**From:** Abiel X. Carrillo  
**To:** ["David Soule"](#)  
**Subject:** RE: C18D064B - Legacy NAA Apartments - Stamp Date 3/25/2016  
**Date:** Tuesday, May 10, 2016 11:13:00 AM

**From:** Abiel X. Carrillo  
**Sent:** Thursday, April 07, 2016 12:00 PM  
**To:** David Soule  
**Cc:** Cherne, Curtis  
**Subject:** C18D064B - Legacy NAA Apartments - Stamp Date 3/25/2016

Based on the information provided in your submittal received 3-24-2016, the above-referenced Grading and Drainage Report and Grading Plan cannot be approved for Preliminary Plat, Site Development for Building Permit, or Grading Permit. The plan can be approved for Site Plan for Subdivision, however, since it only involves the consolidation of the lots. The following sets of comments would need to be addressed prior to the applicable approval:

**Preliminary Plat and Site Plan for Building Permit (DRB #1009881):**

|                                                             | <br>Rio Grande<br>Engineering<br>1606 CENTRAL AVENUE<br>SUITE 201<br>ALBUQUERQUE, NM 87106<br>(505) 872-0898 | SHEET #<br>C1<br>JOB #<br>21331                             |

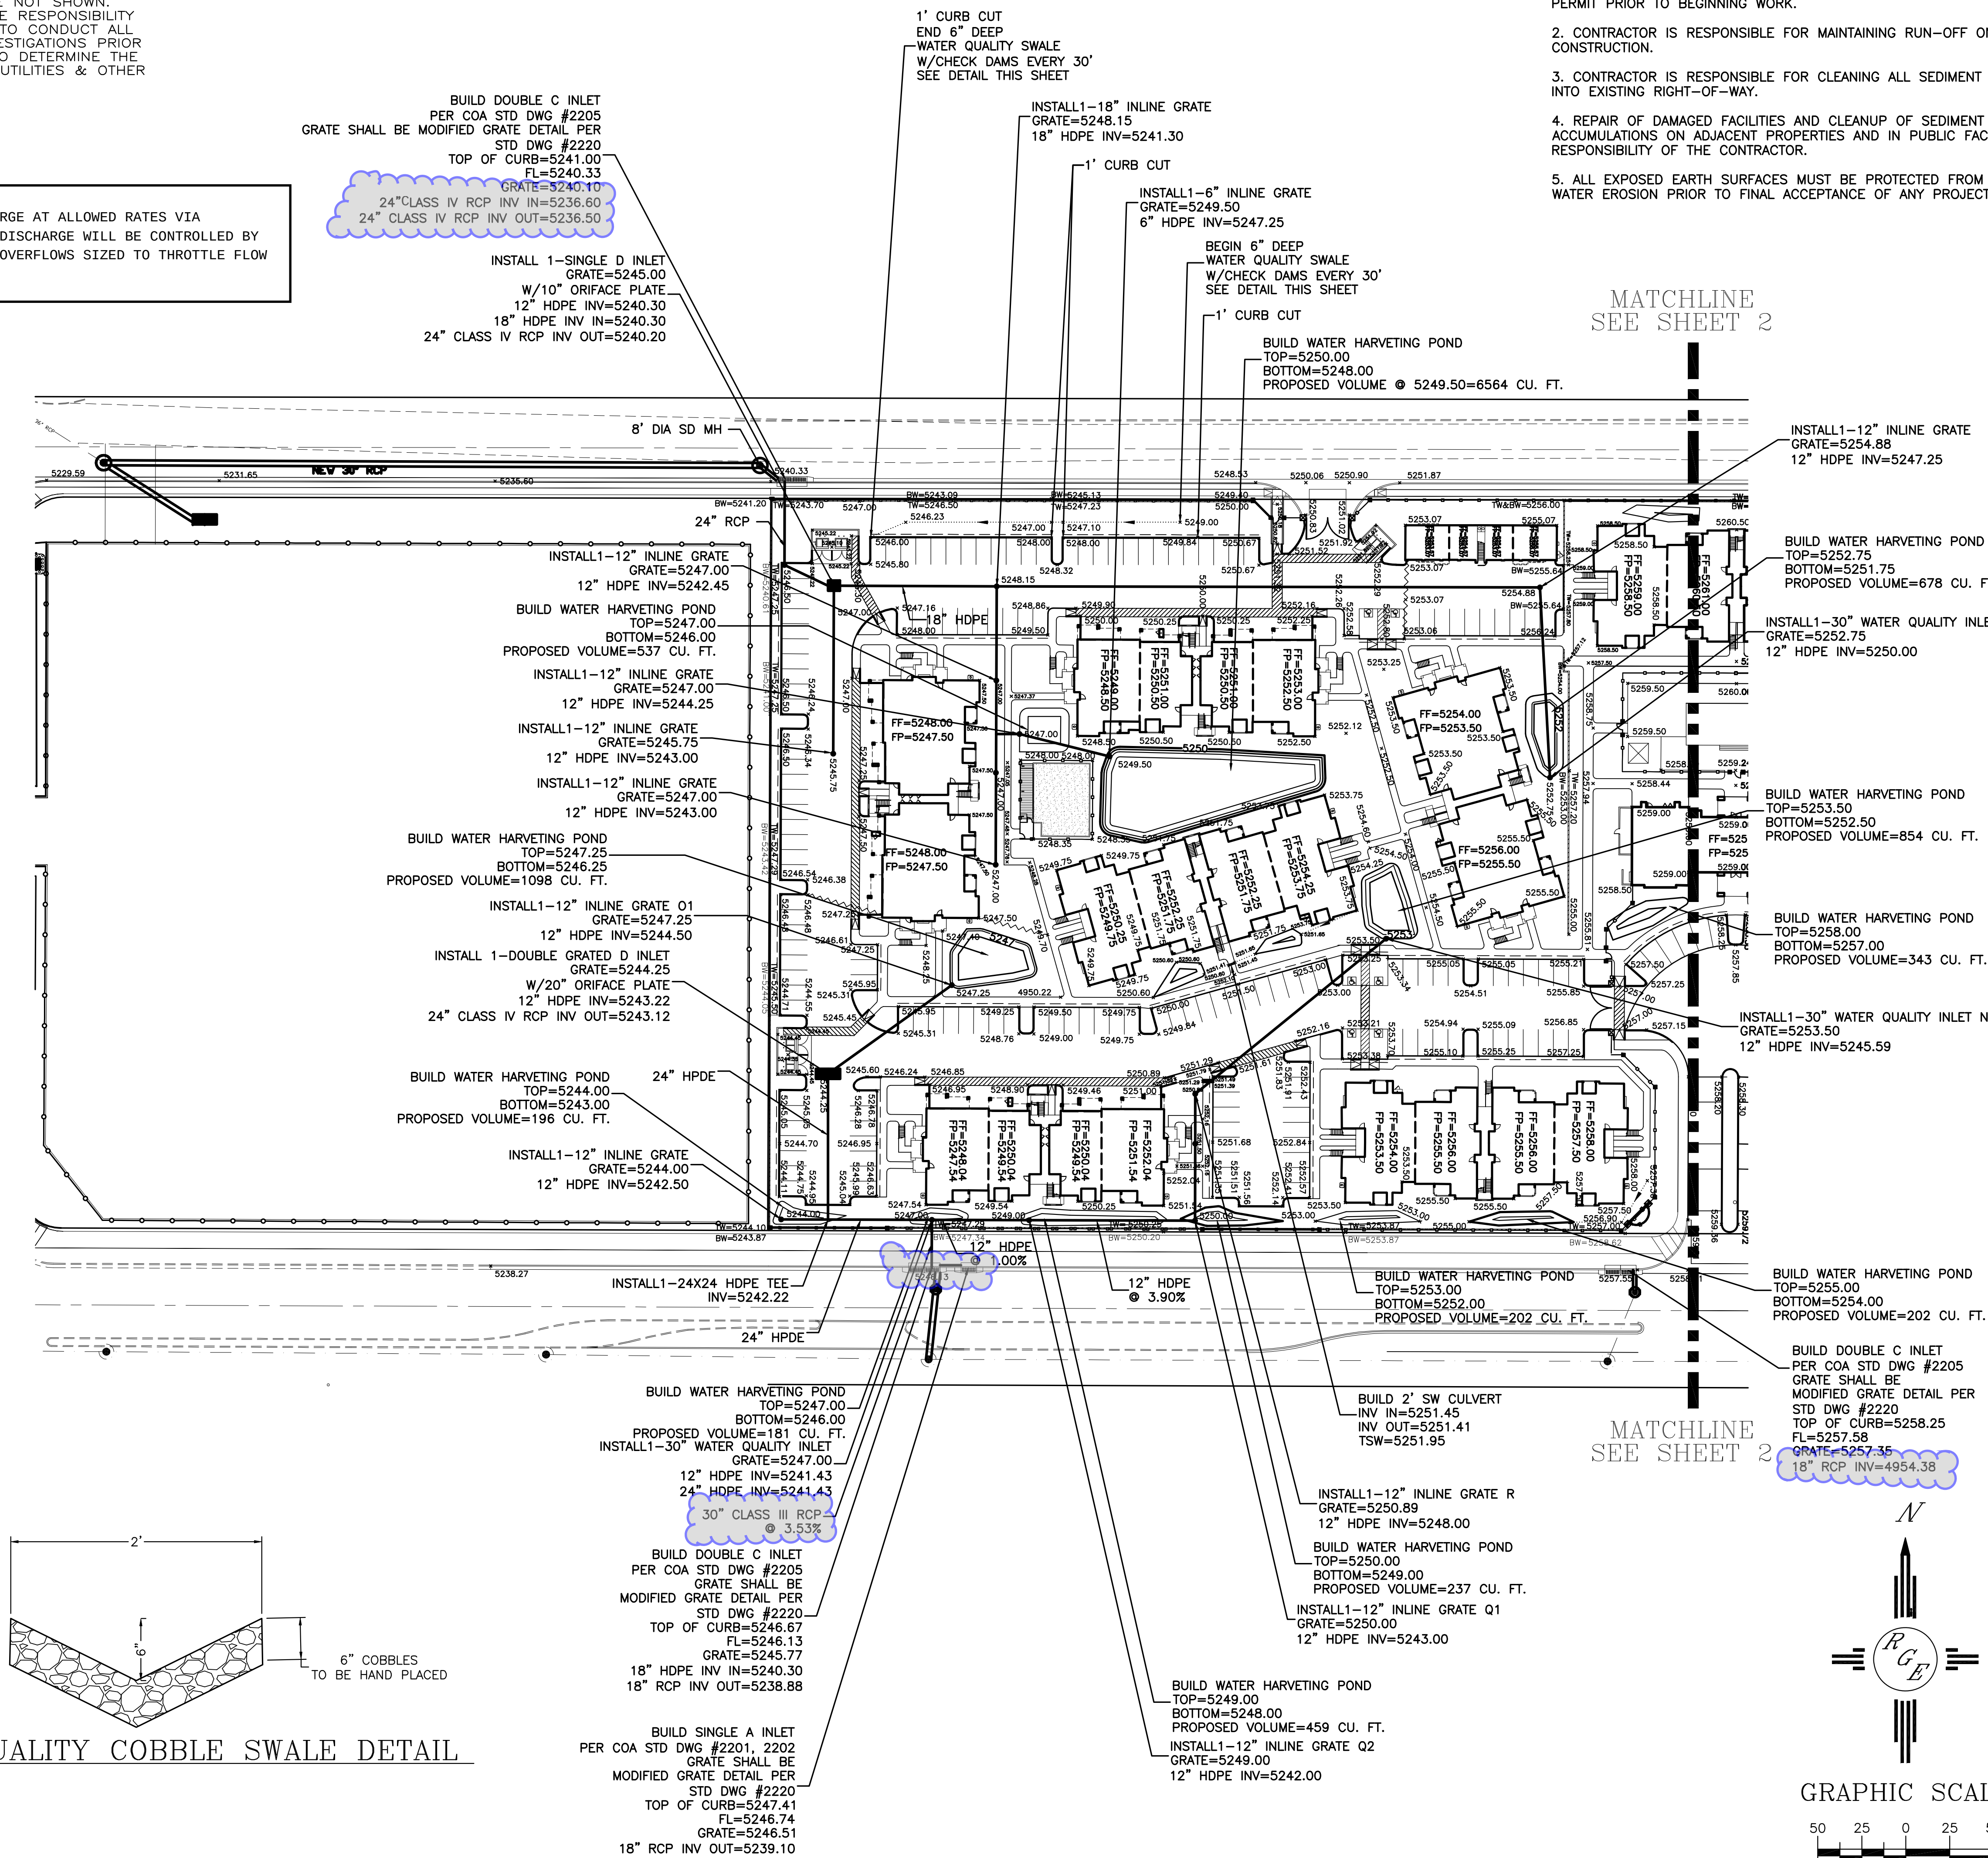
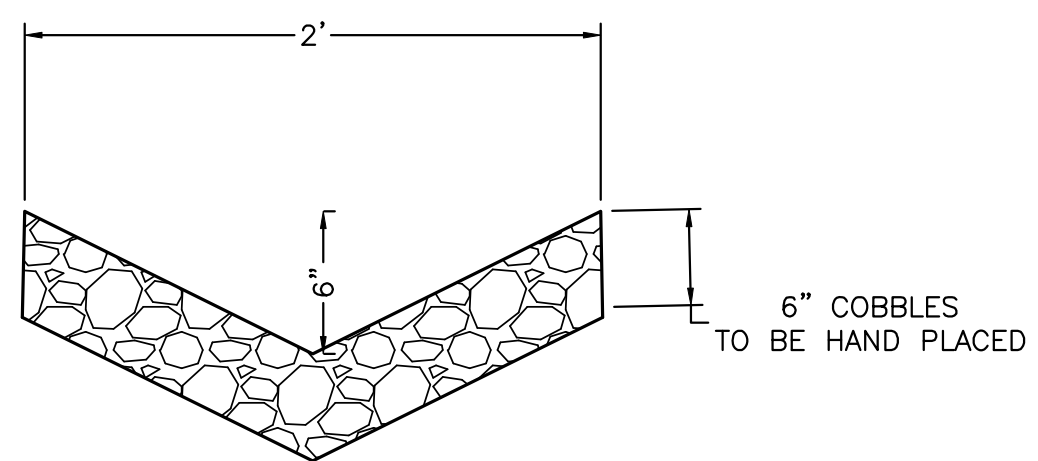
3. All pipes in the City Right of Way need to be either RCP or HPPP, the connection into the Oakland Ave Right of Way shows a 12" HDPE extension into the inlet. [The attached plan has the corrected rcp within the right of way](#)

|                            |                                                                                                                                                                                                | SHEET # C4           |

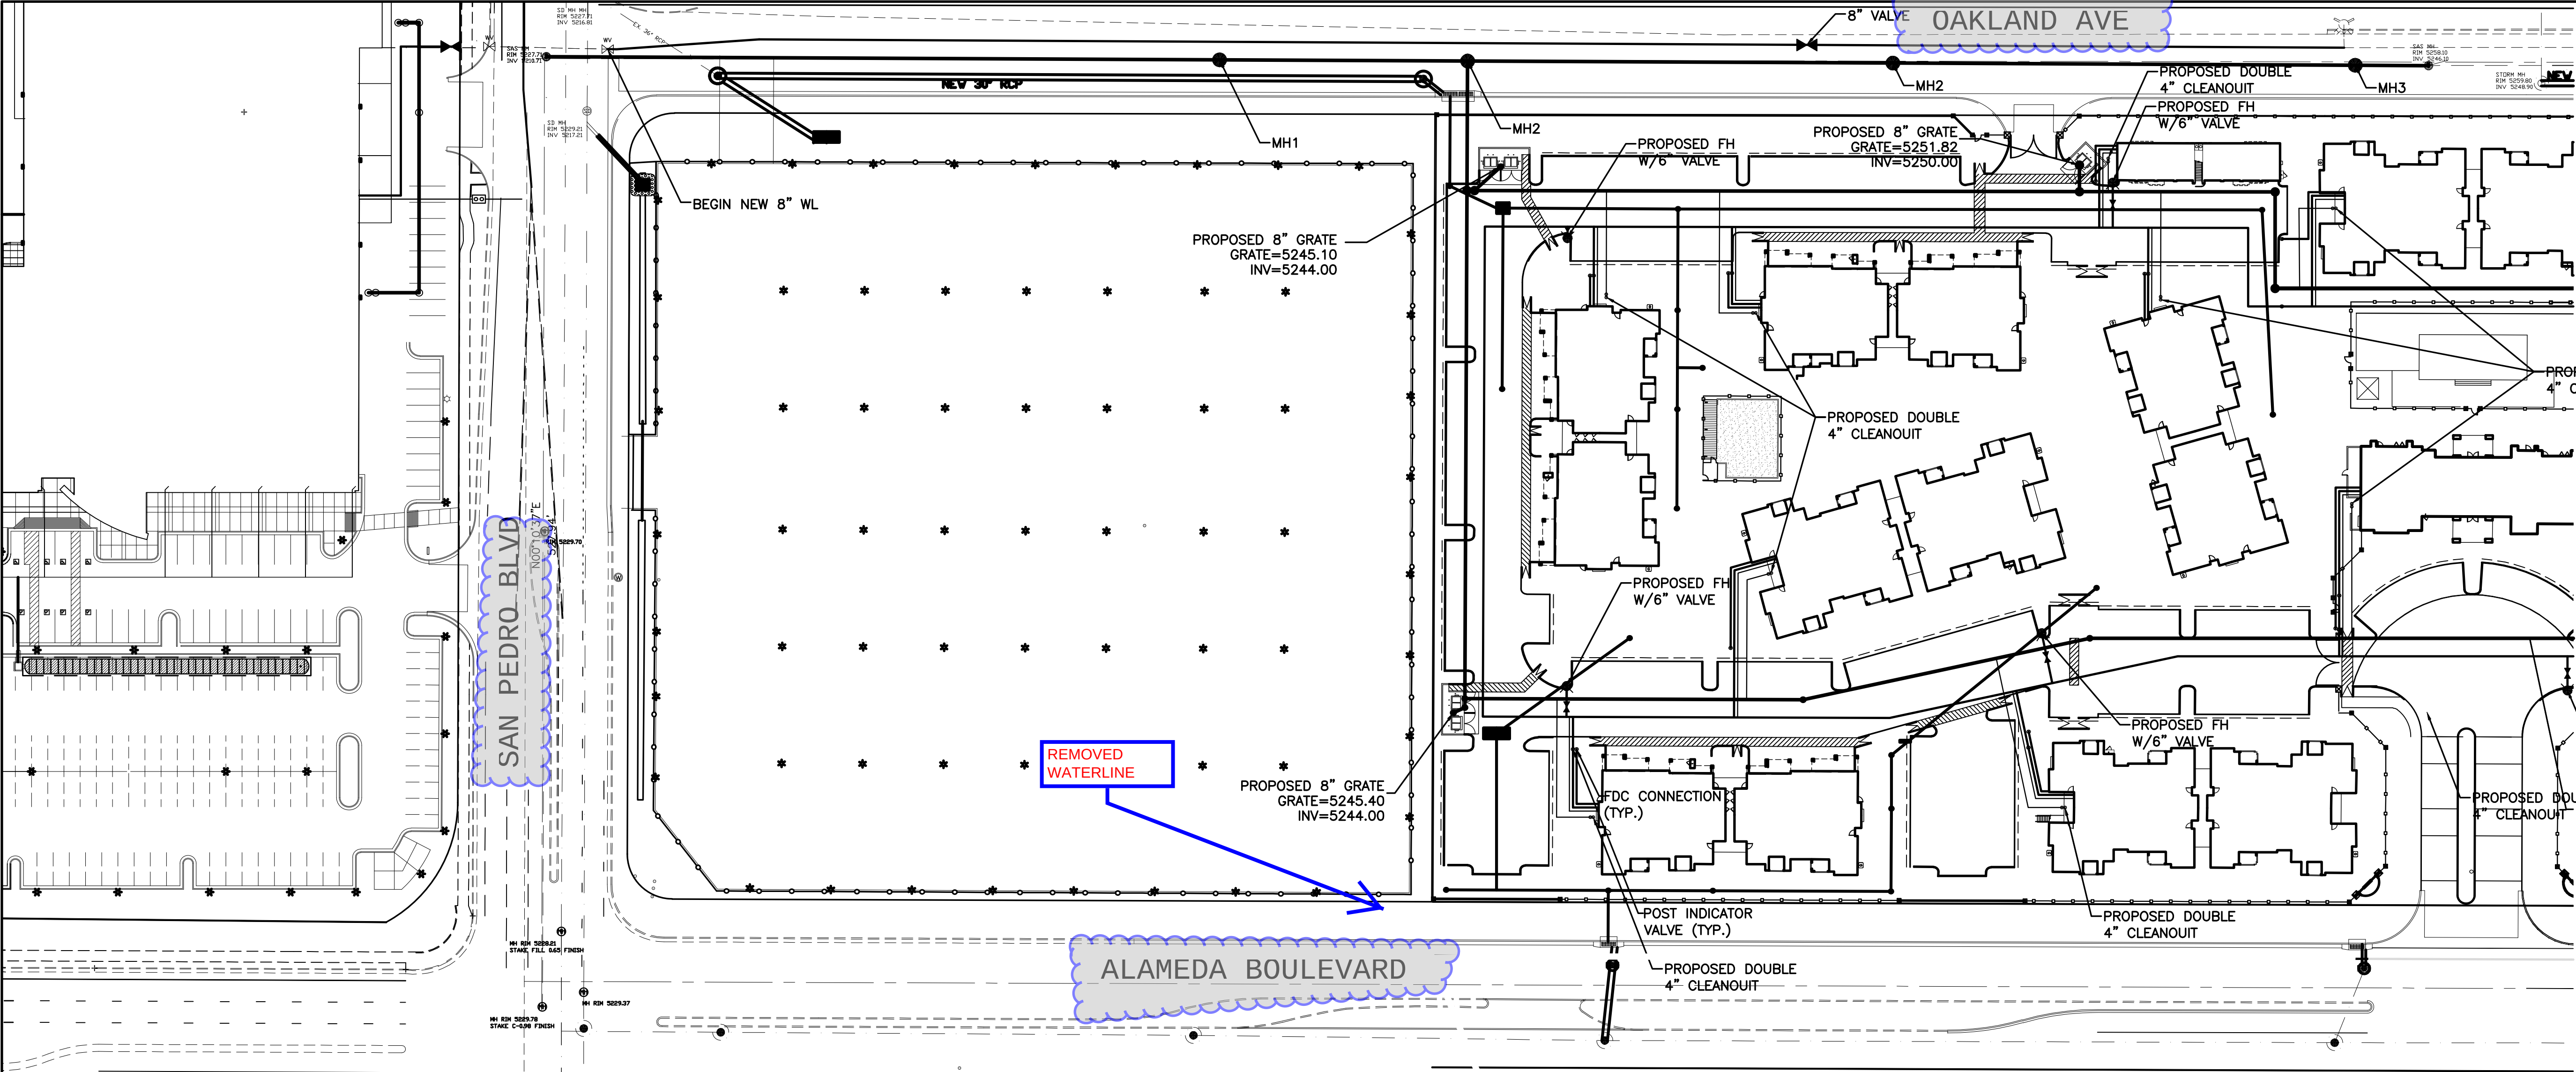
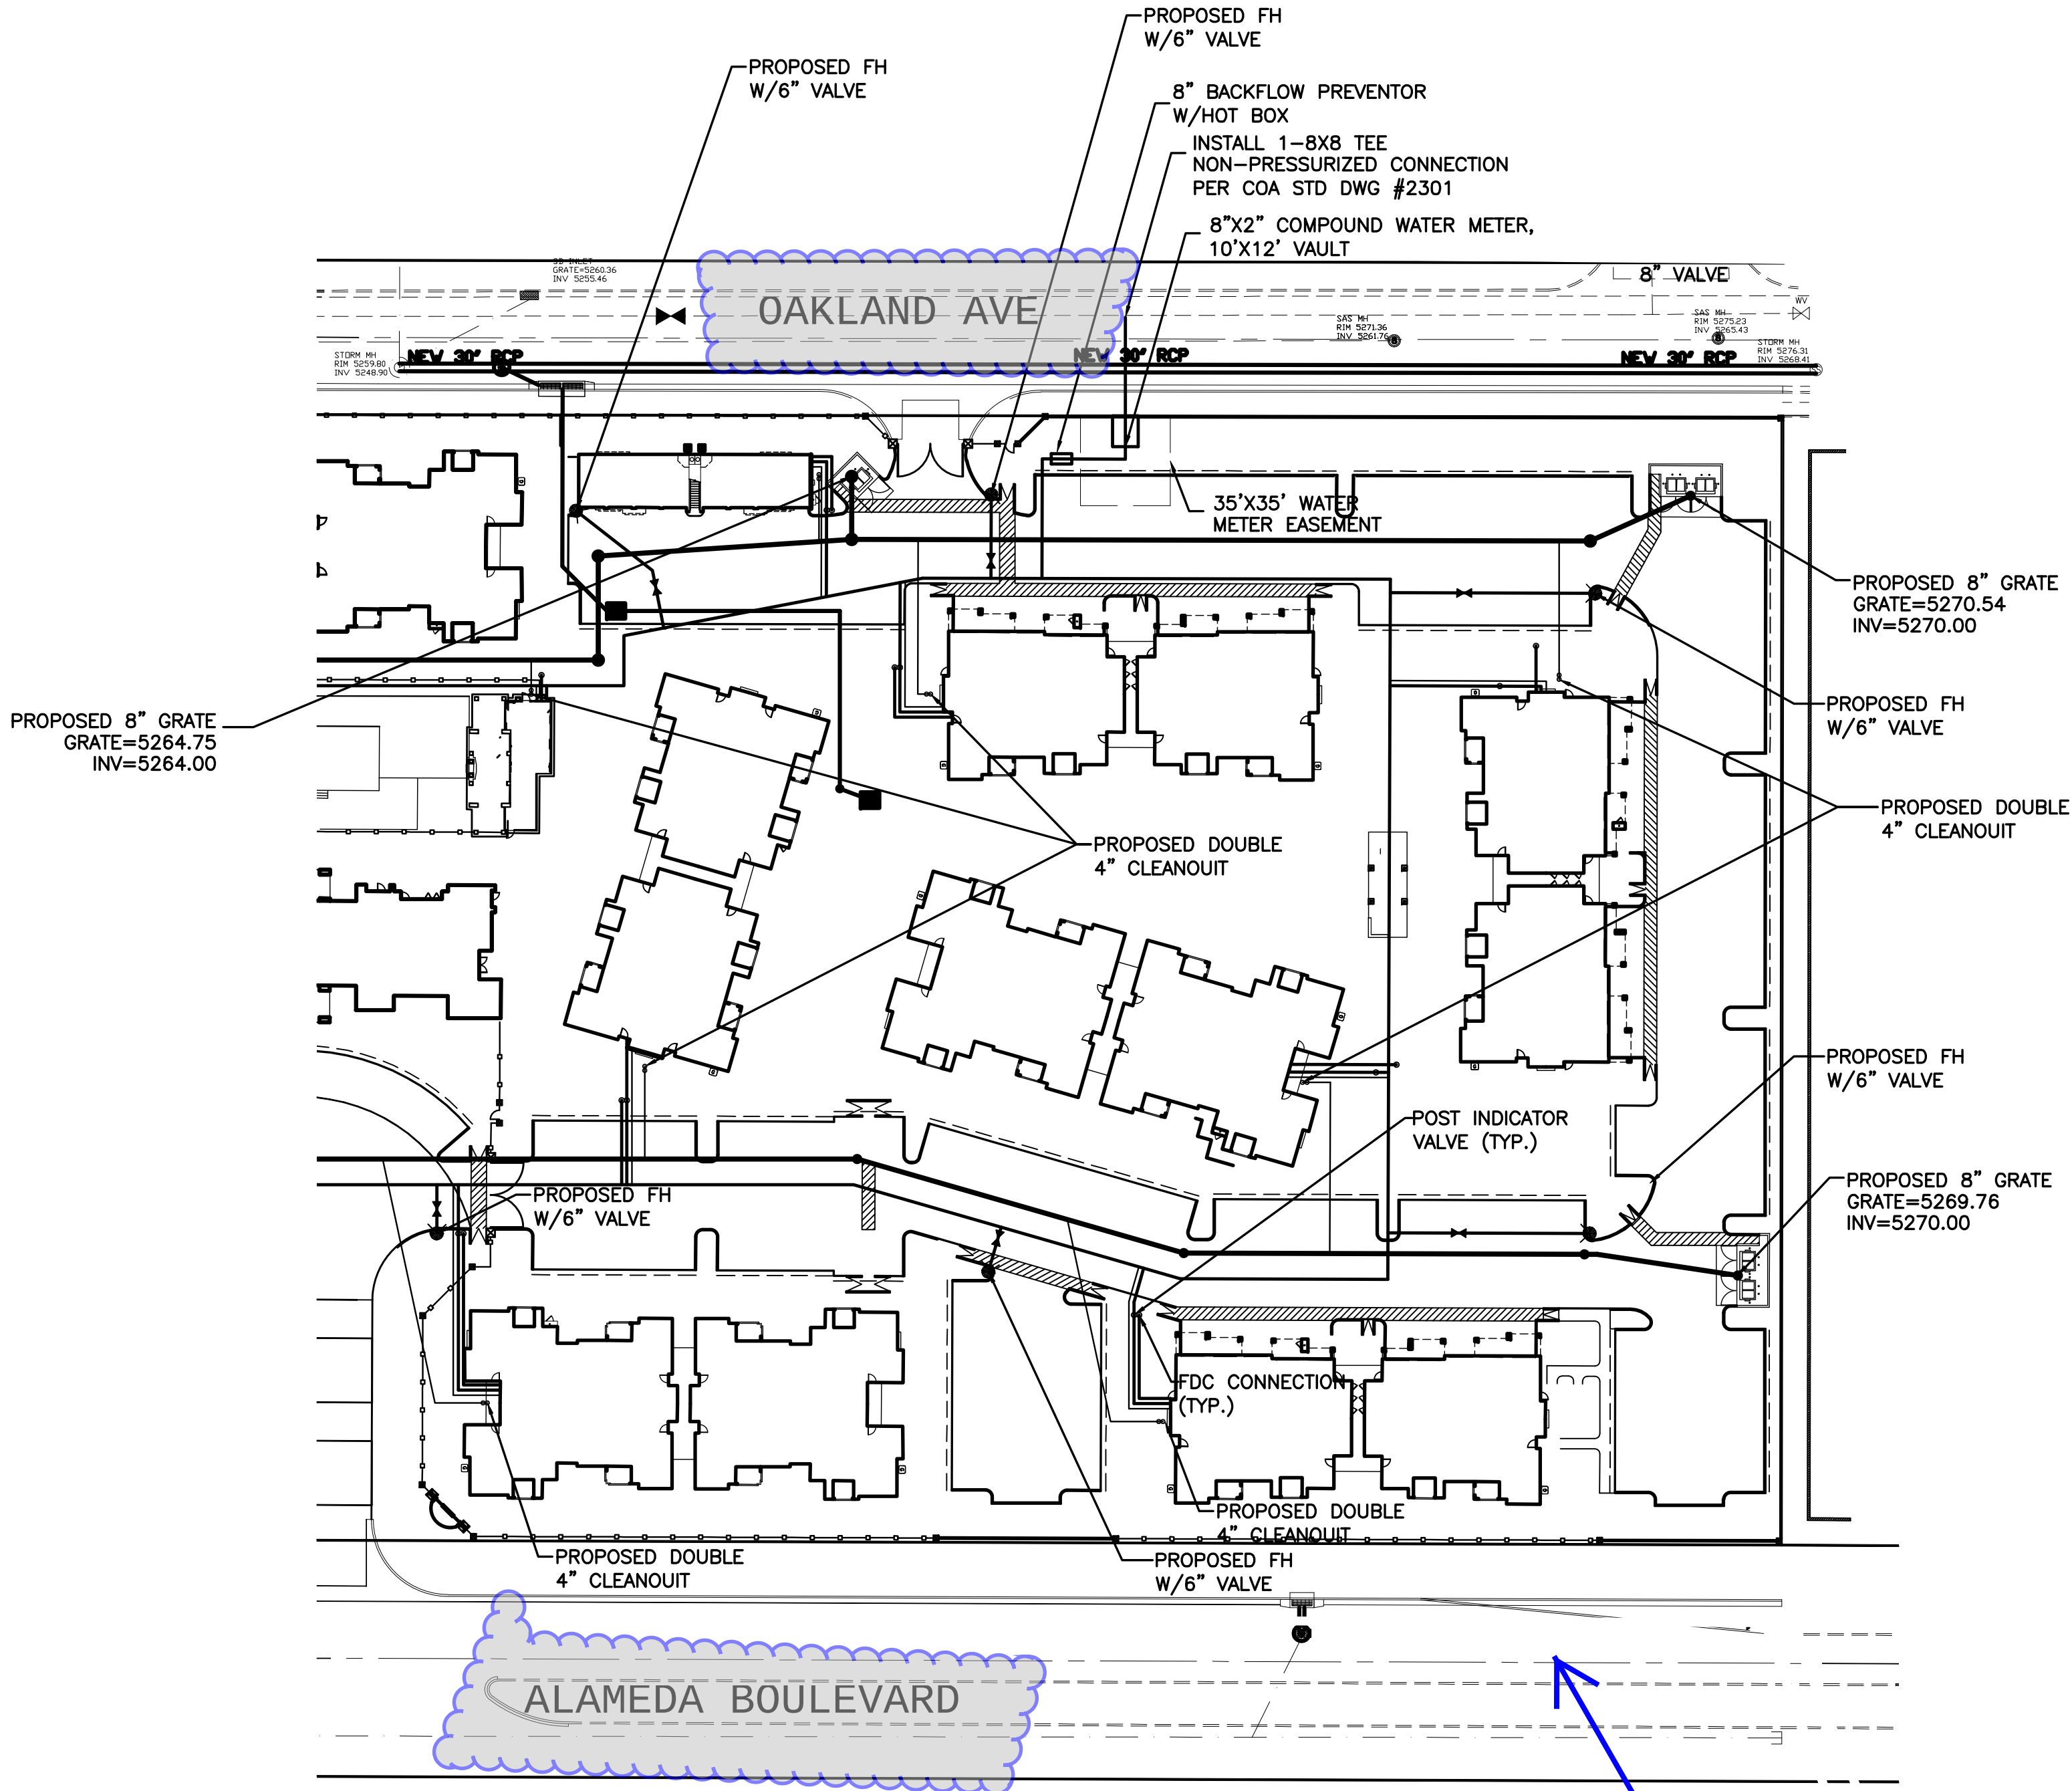
1. The Report (or a supplement) needs to show how the inlet types and sizes were selected along Alameda and Oakland. The Infrastructure List (which is tied to the SPBP) needs to reflect the sizes and types as well, since the work order involves removing and replacing inlets, and only installing a portion of the trunk along the frontage. [Please find revised Infrastructure list showing the double C and single A inlet at each existing stub.](#)

Abiel, please find the attached revised infrastructure list and site plan package, We have added additional inlets to the existing stubs and provided RCP to all the inlets in the right of way. We are having weekly design meeting with the architect so some of the grading will be slightly adjusted and we will submit the report in accordance with your additional comments below. Thank you very much  
David Soule  
Rio Grande Engineering  
321.9099
